**SHEARON HARRIS NUCLEAR POWER PLANT, UNITS 2 AND 3  
DOCKET NOS. 52-022 AND 52-023  
RESPONSE TO REQUEST FOR ADDITIONAL INFORMATION LETTER NO. 078 RELATED TO  
RADIATION PROTECTION DESIGN FEATURES - CONSTRUCTION WORKER DOSE**

**Shearon Harris Nuclear Power Plant Units 2 and 3  
Response to NRC Request for Additional Information Letter No. 078 Related to  
SRP Section 12.3-12.4 for the Combined License Application, dated February 15, 2011**

**NRC Letter No.:** HAR-RAI-LTR-078

**NRC RAI NUMBER:** 12.03-12.04-3

FIGURE 12.4-202

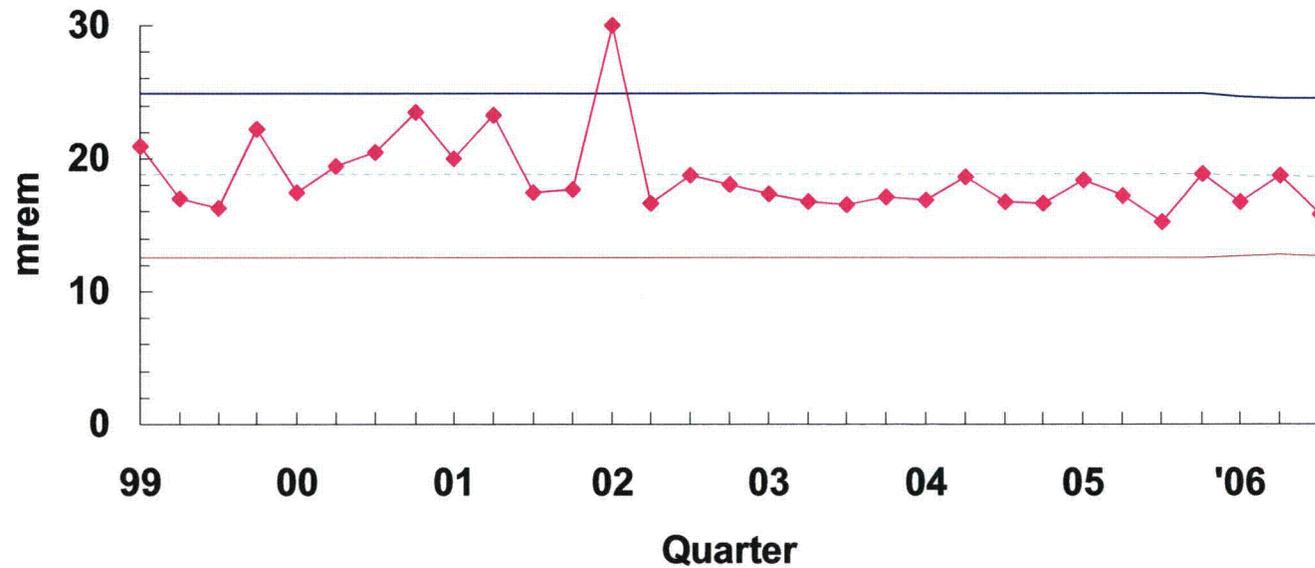
2. Figure 12.4-202 will be revised to indicate the quarterly dose at Protected Area Fence TLD # 7 (see attachment).
3. Add the following paragraphs to the end of Subsection 12.4.1.9.2:

The maximum dose of gamma radiation over any 90-day period for TLD # 7 was approximately 32 mrem (without background correction) as shown on Figure 12.4-202. Using the 32 mrem per 90-day period value for TLD # 7 for estimating the doses to construction workers is considered both reasonable and conservative because:

Revised Figure 12.4-202 (Revision 4 Draft) – Quarterly Dose at Protected Area Fence TLD # 7

Revised Figure 12.4-202 (Revision 4 Draft)

Quarterly Dose at Protected Area  
Fence TLD #7
